EAGLE RANCH ROAD, N.W.

CHANGE ORDER NO. 7

SHEETS 1,4,5,6,7,8,9,10,11

The above-mentioned sheets are temporary additions to the final plans for Eagle Ranch Road. They outline the paving plan for completing approximately one half of the road as directed by the owner. Upon completion of the entire road section, these sheets shall be replaced by the originals.

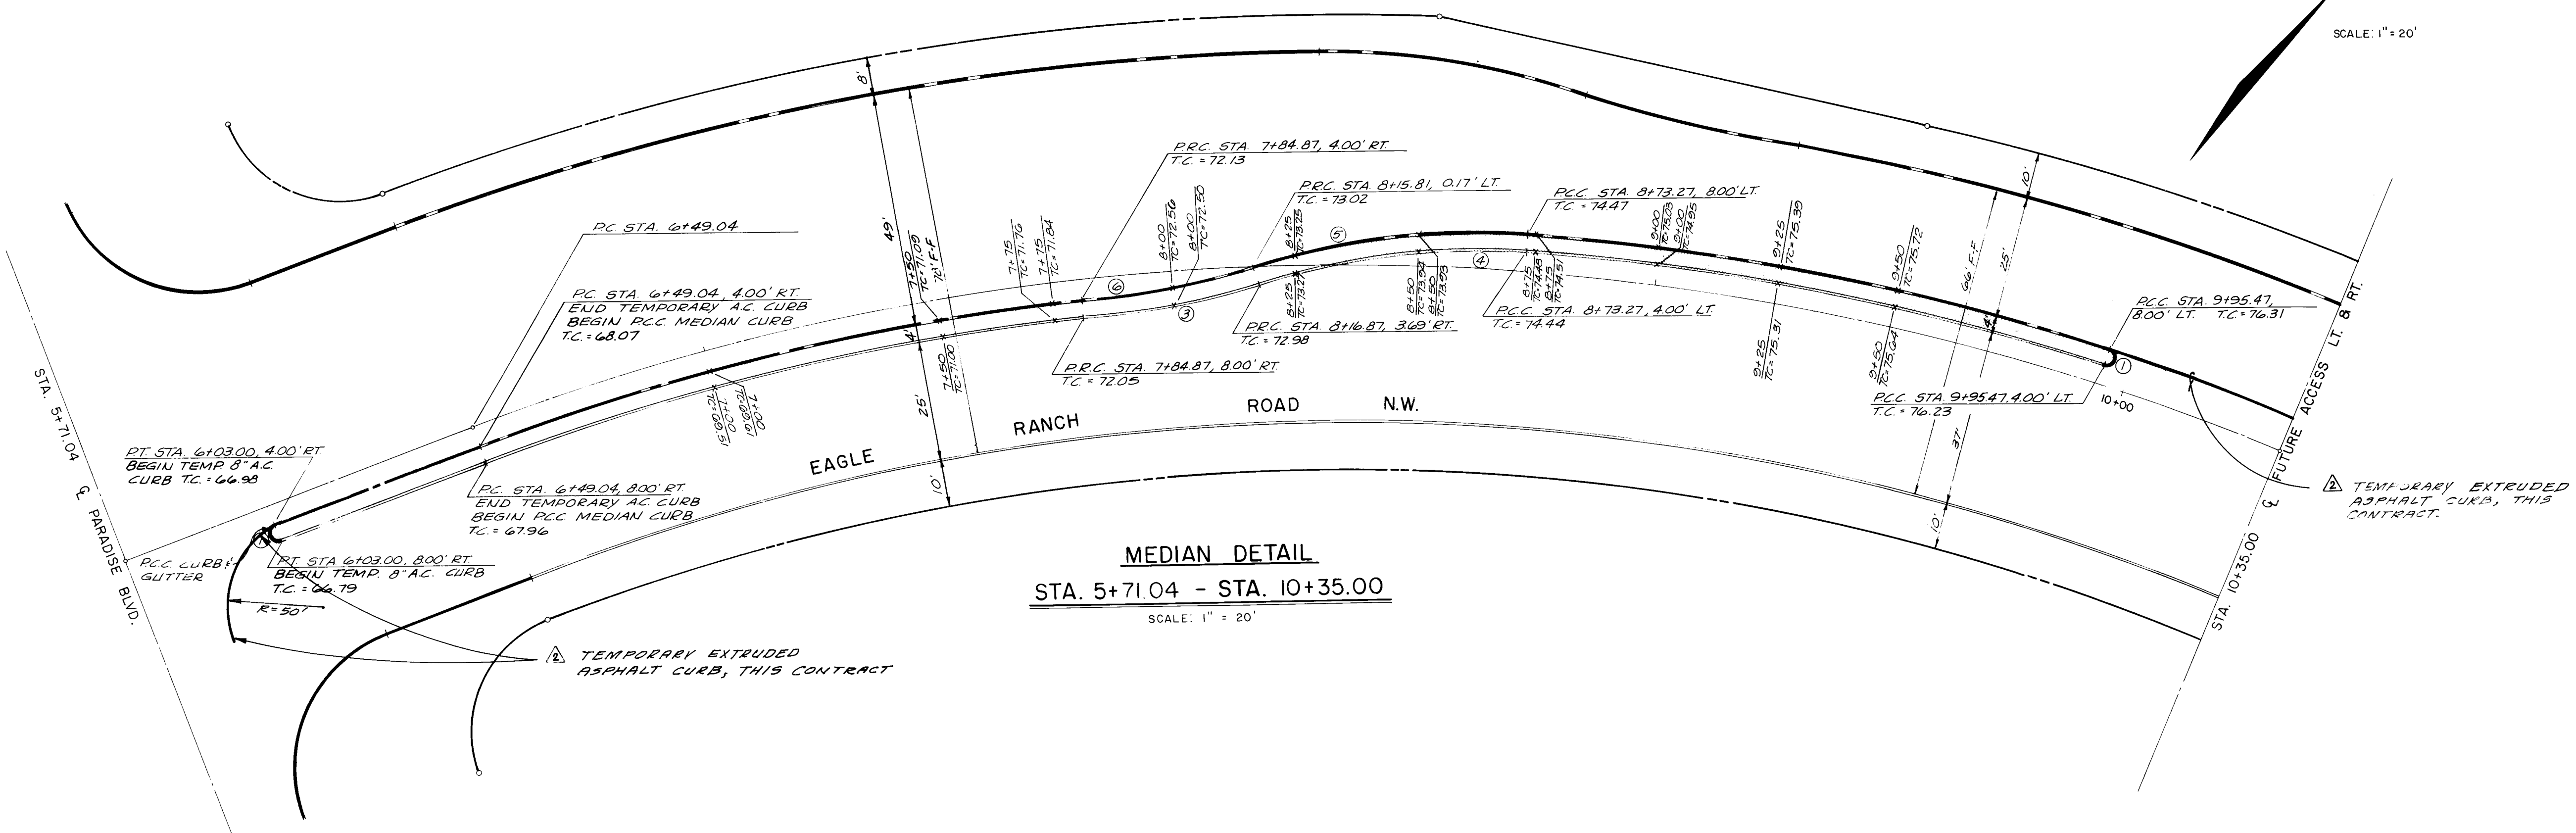
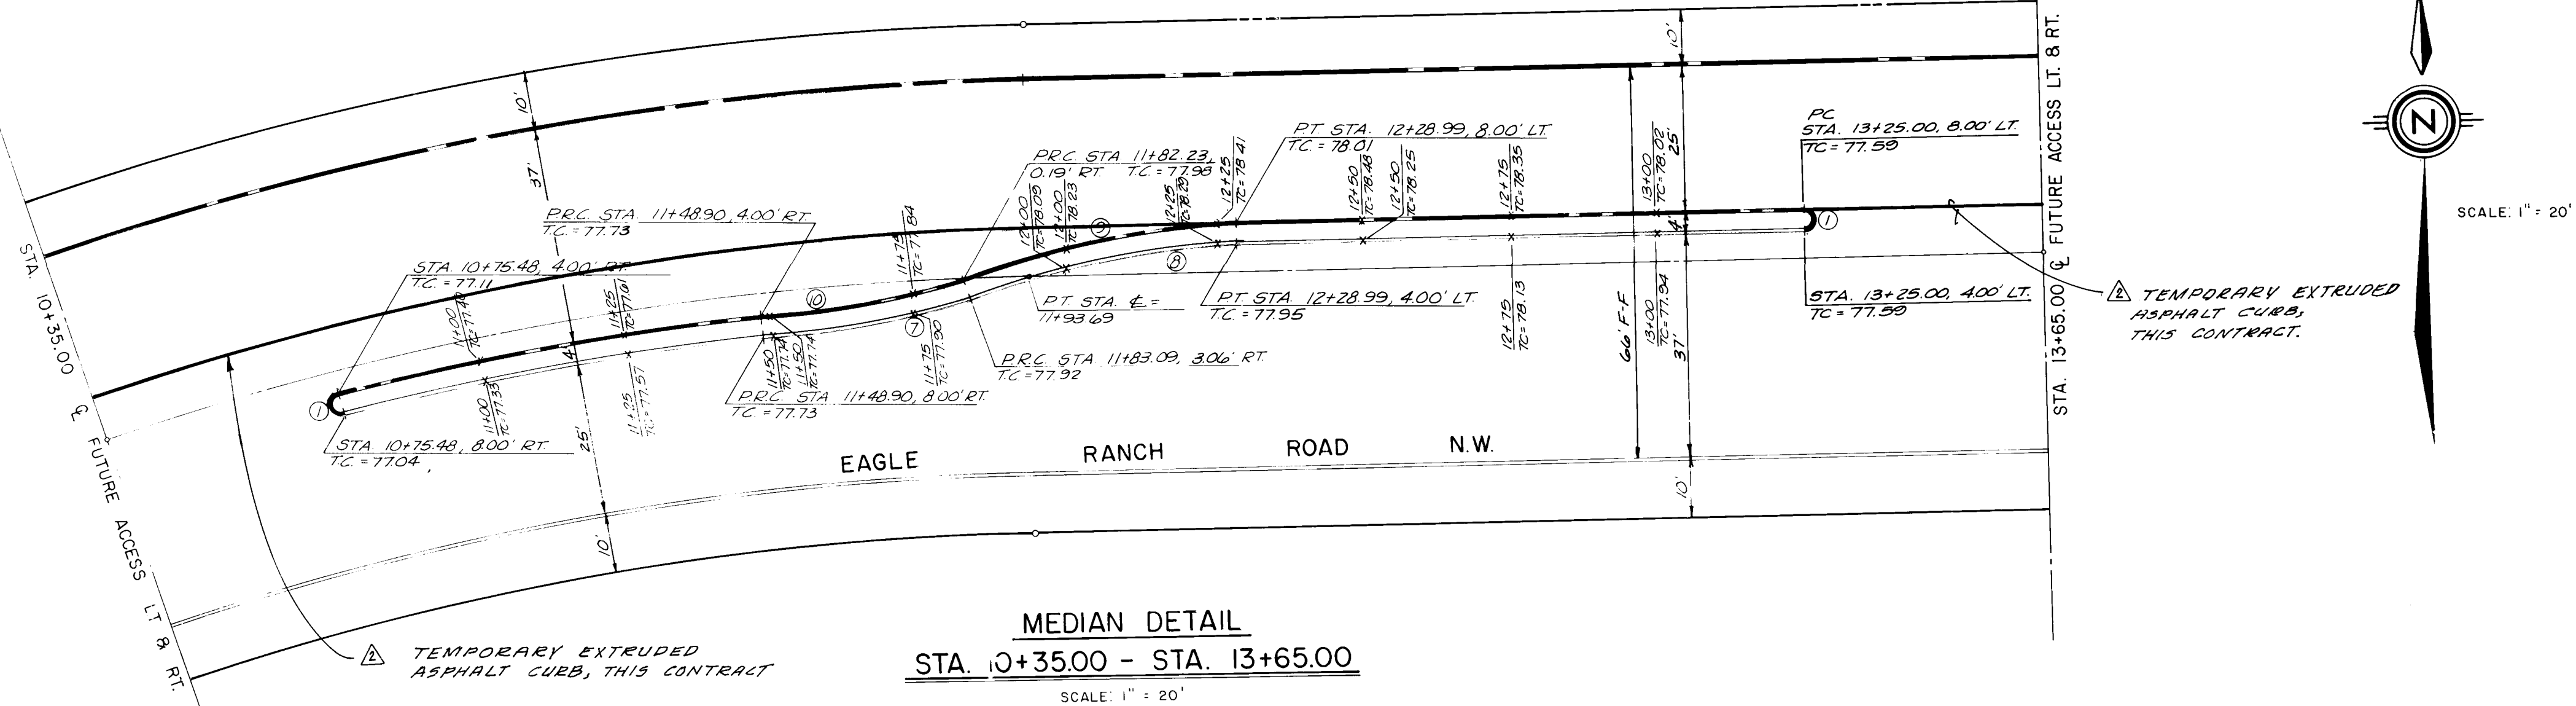
PERMANENT CURB AND GUTTER TO BE BUILT THIS CONTRACT.

TEMPORARY EXTRUDED ASPHALT CURB, THIS CONTRACT.

The above-mentioned sheets are temporary additions to the final plans for Eagle Ranch Road. They outline the paving plan for completing approximately one half of the road as directed by the owner. Upon completion of the entire road section, these sheets shall be replaced by the originals.

Note that no alterations were made to any permanent horizontal or vertical alignments. The only changes on these sheets involve temporary elimination of road section, curb and gutter and temporary construction of asphalt pavement and curb, which were drawn by Easterling & Associates, Inc., February, 1986.

DRAWING NO. 2440 MAP NO. C-13 SHEET 9 OF 16

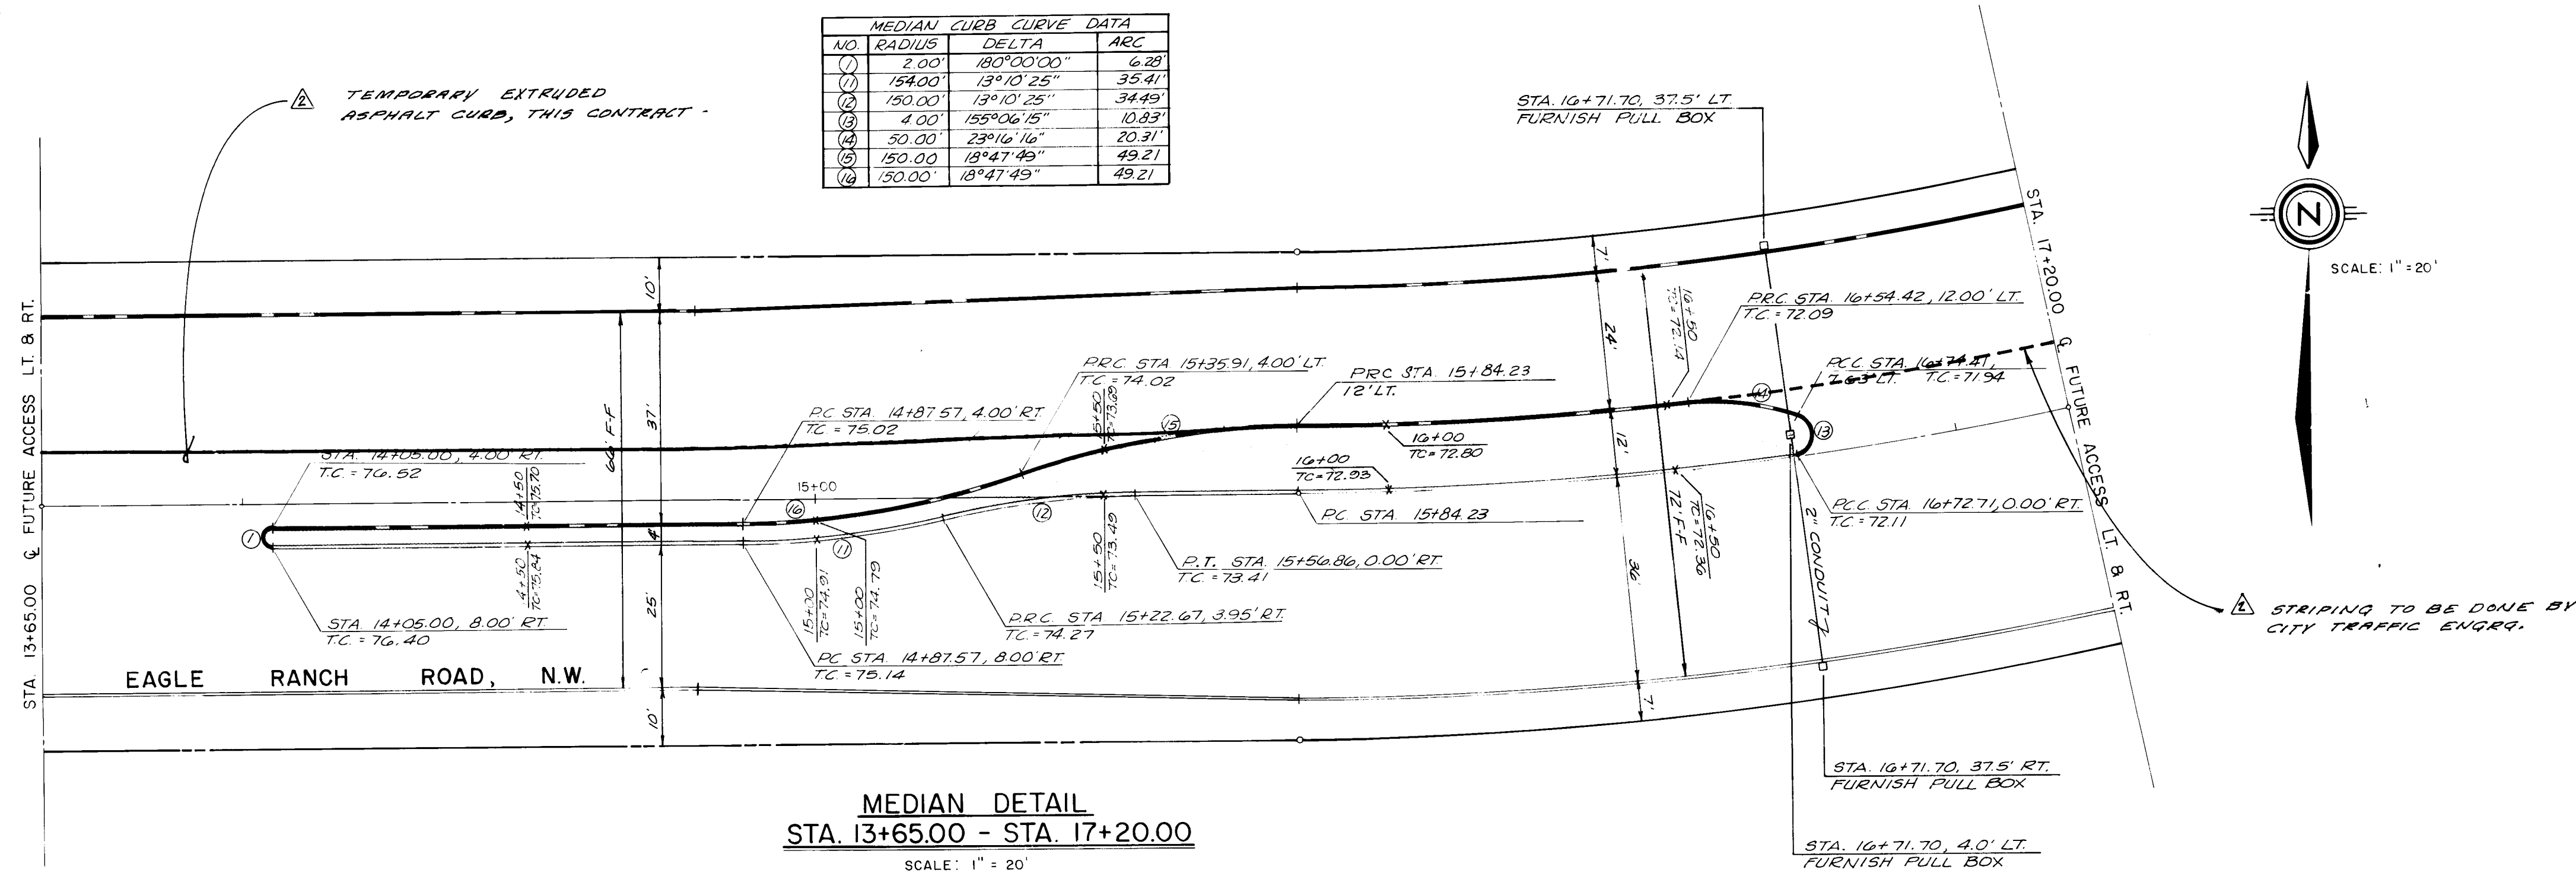
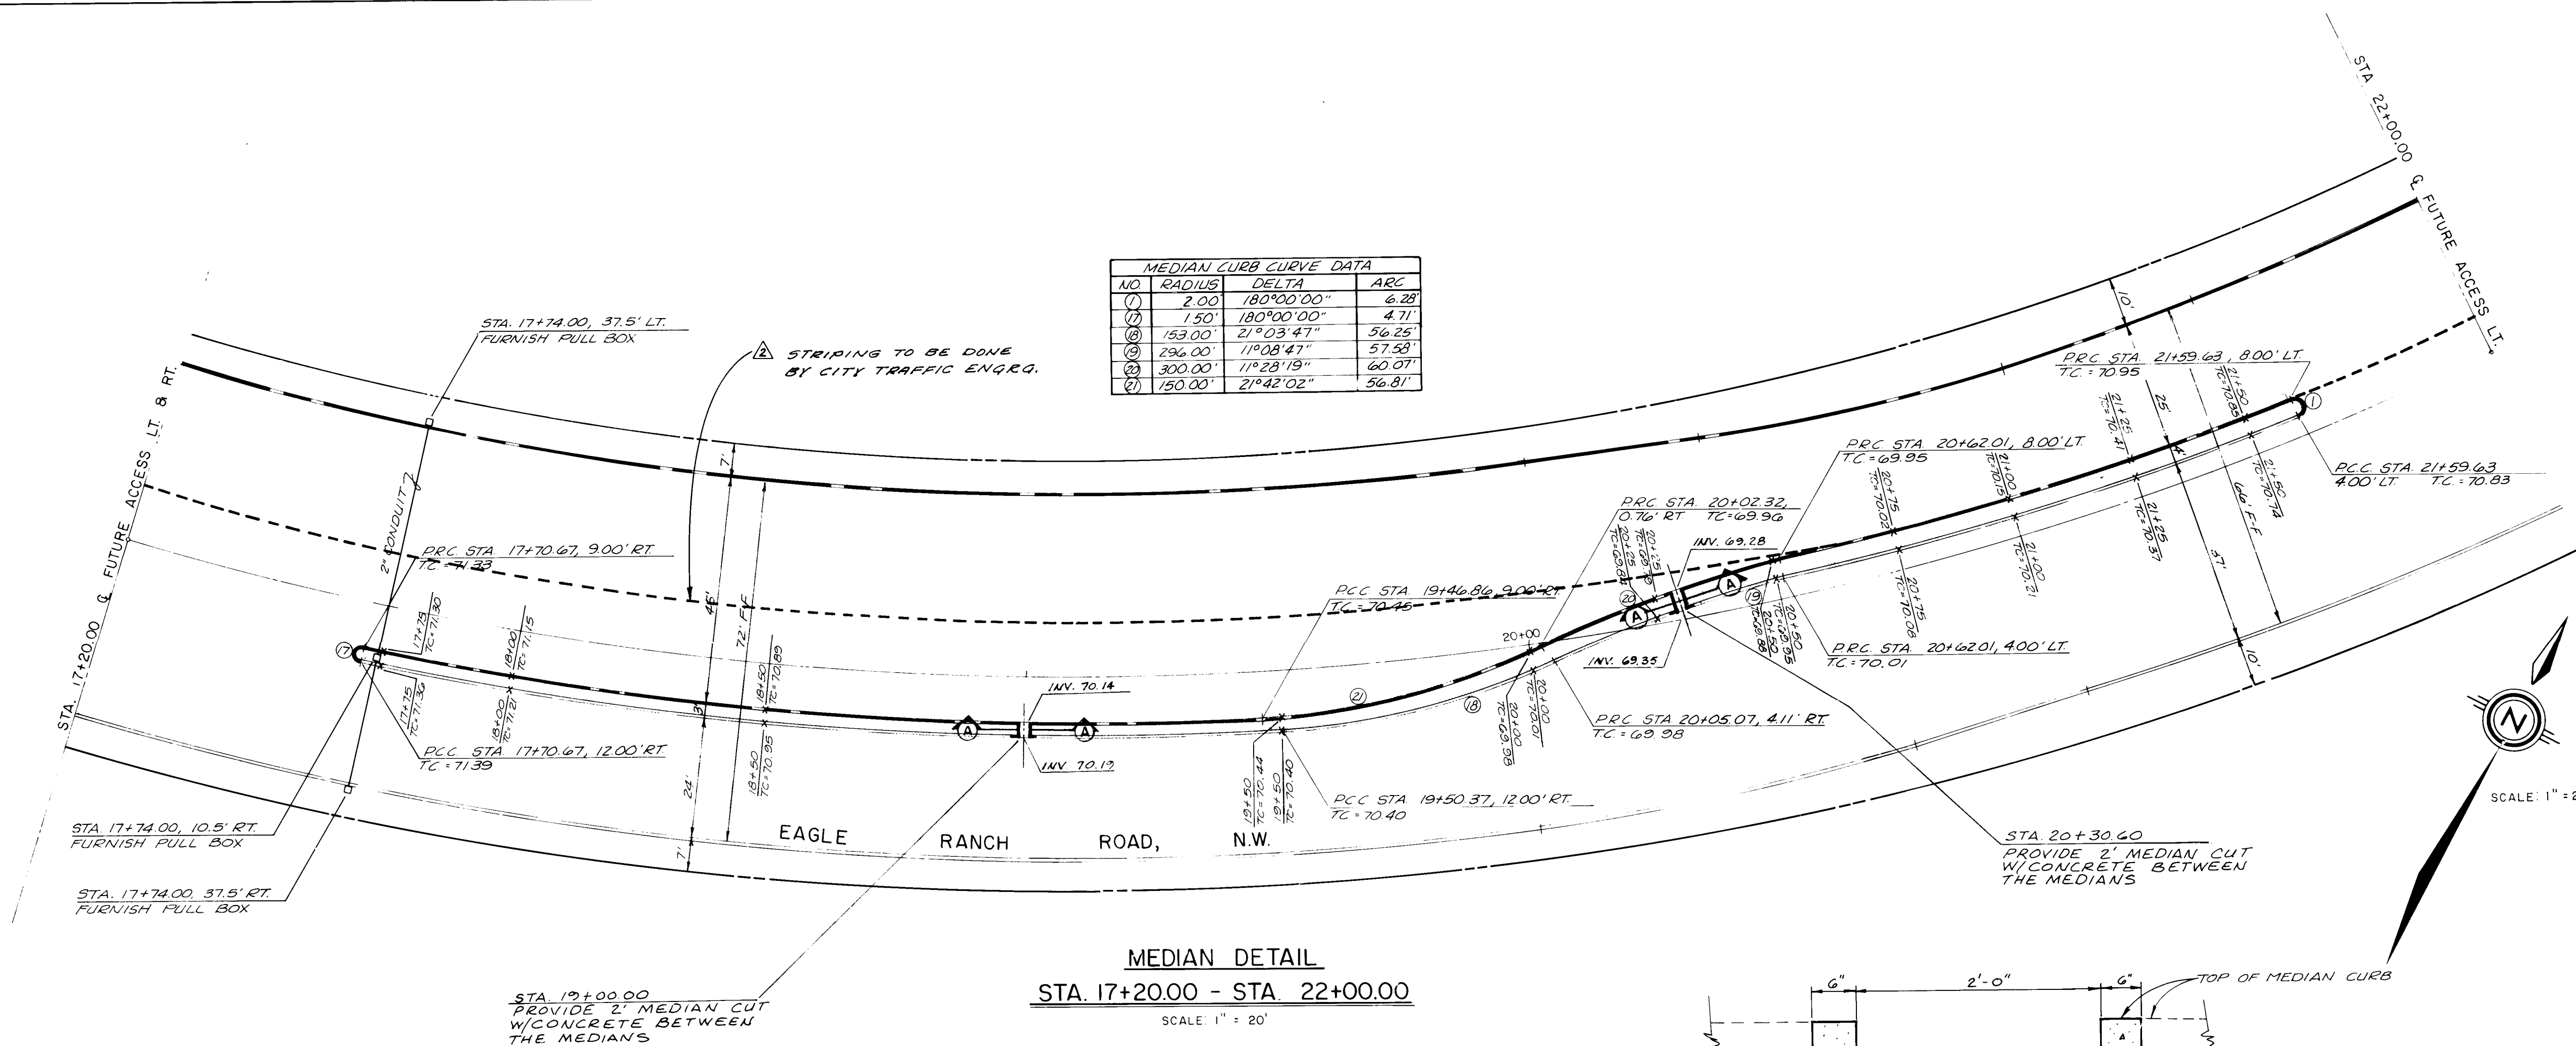
PERMANENT CURB AND GUTTER TO BE BUILT, THIS CONTRACT.

TEMPORARY EXTRUDED ASPHALT CURB, THIS CONTRACT.

The above-mentioned sheets are temporary additions to the final plans for Eagle Ranch Road. They outline the paving plan for completing approximately one half of the road as directed by the owner. Upon completion of the entire road section, these sheets shall be replaced by the originals.

Note that no alterations were made to any permanent horizontal or vertical alignments. The only changes on these sheets involve temporary elimination of road section, curb and gutter and temporary construction of asphalt pavement and curb, which were drawn by Easterling & Associates, Inc., February, 1986.
